GULMOHAR RESIDENCY

Details of Additions & Alterations

Flat No	506	Block no.	' D '
Flat Area	1660 sft	Type	✓ Deluxe / Luxury
Buyer Name	CH. RAVI PRASAD		
Phone No.	9885094700	Email	chelamallu2@gmail.com.

Description	Direction	Owners & Developers :	Date :	25.09.2020			Scale :	N.T.S	Phone :+91-40-60335551
				Prepared By :	Approved By :	Modi Properties Pvt Ltd			
WORKING PLAN-1660 Sft-B1 TYPE	N 	Modi Reality Mallapur LLP	Prepared By :	Jyapradha	Approved By :	Soham Modi			
		Project Name & Phase :	Gulmohar Residency

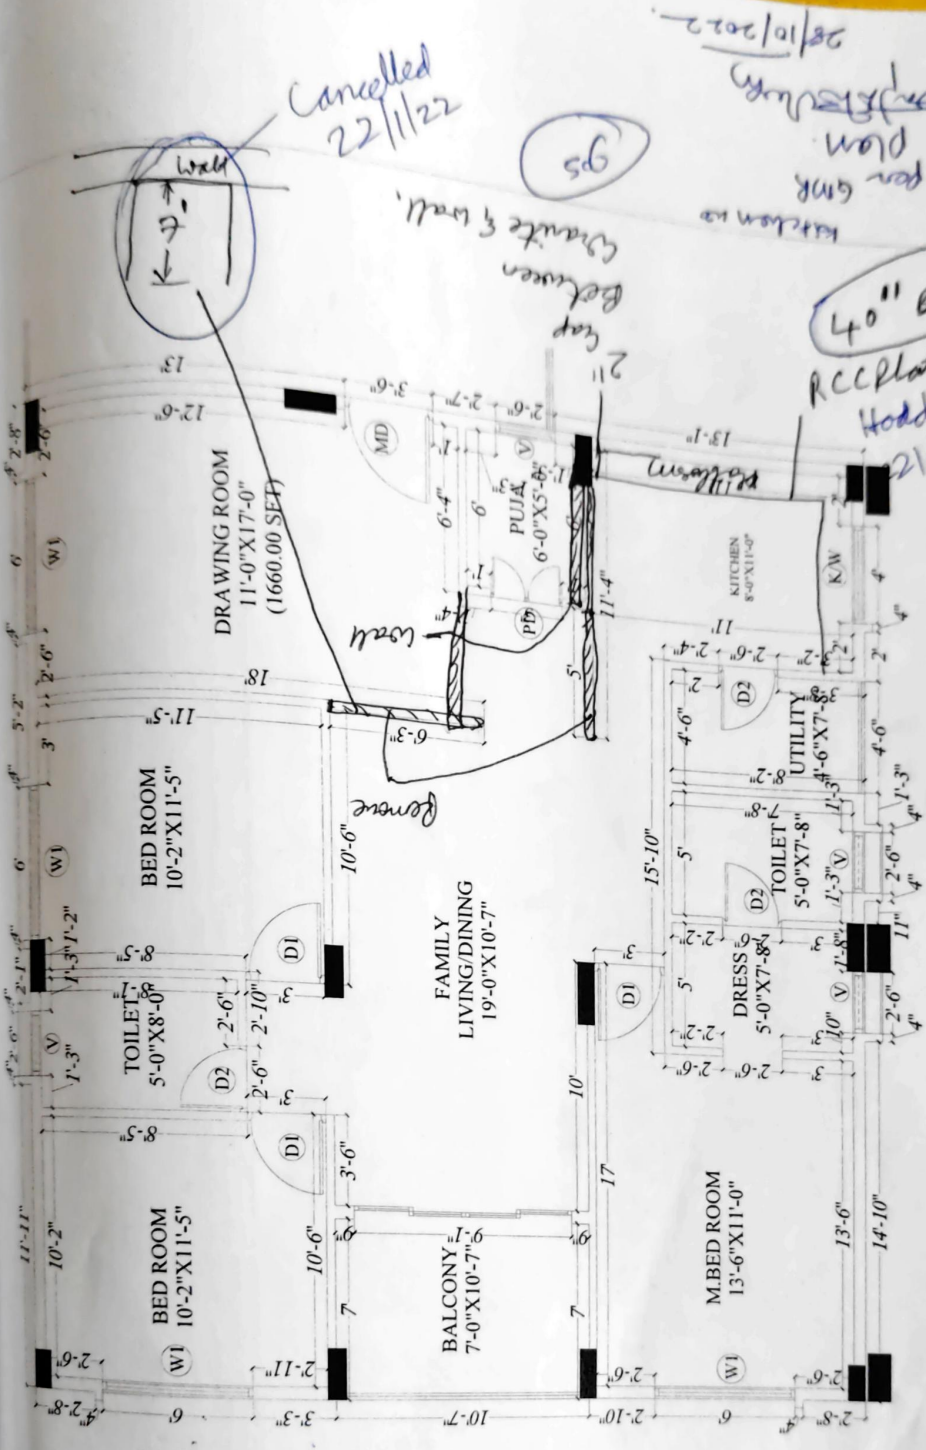
Changes in kitchen platform: (mark on plan)

- 1) Kitchen Granite provided by customer
- 2) RCC platform in kitchen 2" gap between wall & granite
- 3) Kitchen Sink to be provide by customer
18" X 24" - size.

Other Changes:

- 1) Plumbing Points as per plans.

ELECTRICAL PLAN -BI TYPE-1660 sqft

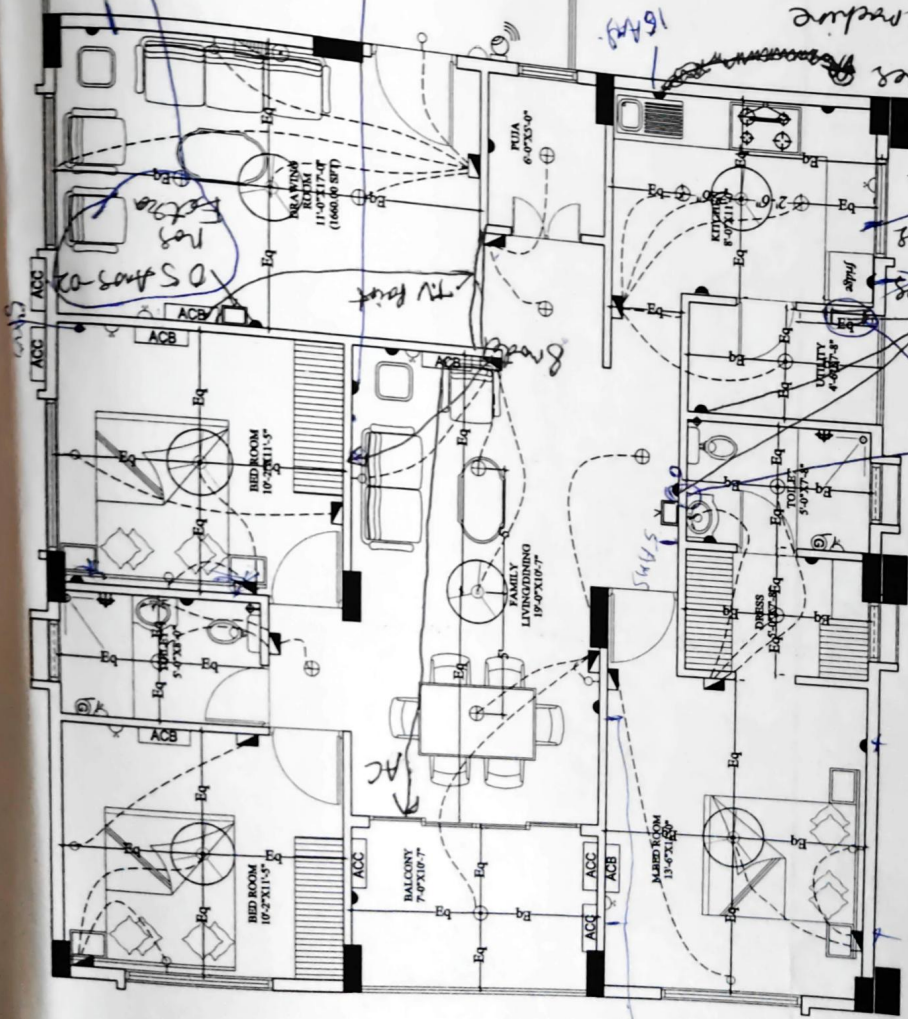
Changes in electrical points: (mark on plan)

1) marked as per plan changes work

22x2 8 Amps
 22/11/22
 cancelled

16 Amps
 22/11/22
 cancelled

QC-B-BLOCK ELECTRICAL PLAN - FLATS NO 2-15 TYPE B1

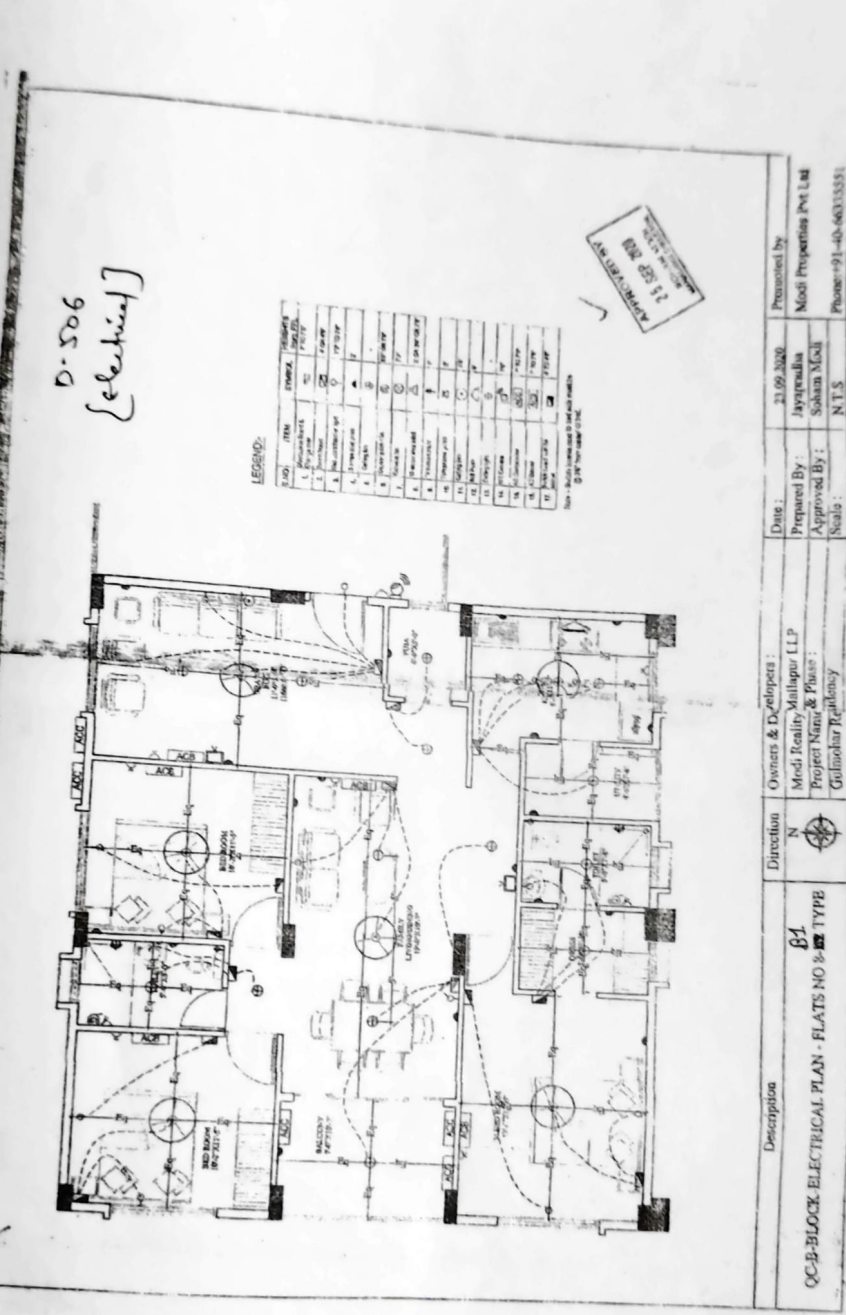
Remarks NOTE :- 1) level marking was not done.

(2) PVC pipes & fasteners were not placed in balcony & utility.
